20 May 2016

Re: DA 0163/2016 Launceston Aquatic Security Fence, 18A High St. Launceston.

TASMANIAN RATEPAYERS ASSOCIATION INC.

Photograph 2 Section of fence to be removed and replaced

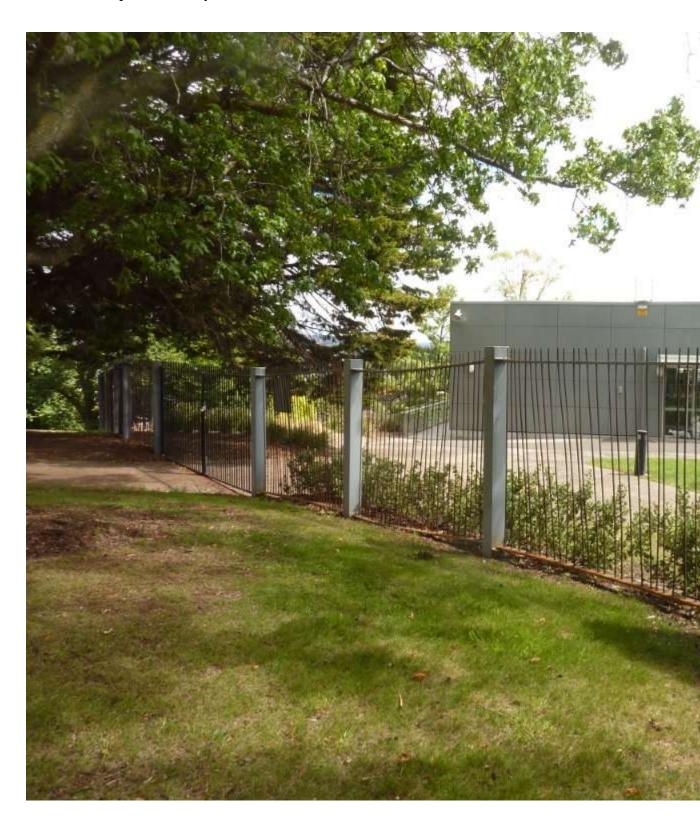
- Why not leave the boundary fence where it is, improve the solid wall sections where presumably the unauthorized access is occurring, and save ratepayers money by not carving off any more of this heritage place unnecessarily?

The section of fence towards the west extending past the Memorial Hall appears to be unchanged, and the solid wall section to the east of the outdoor pool and adjoining the changerooms, likewise appears unchanged. There is no drawing or illustration showing what the proposed fence will look like in its actual setting. The mesh panels are rectilinear and will need to have a formed, stepped base wall to counteract the sloping site, with the top being similarly stepped and hence out of character with the
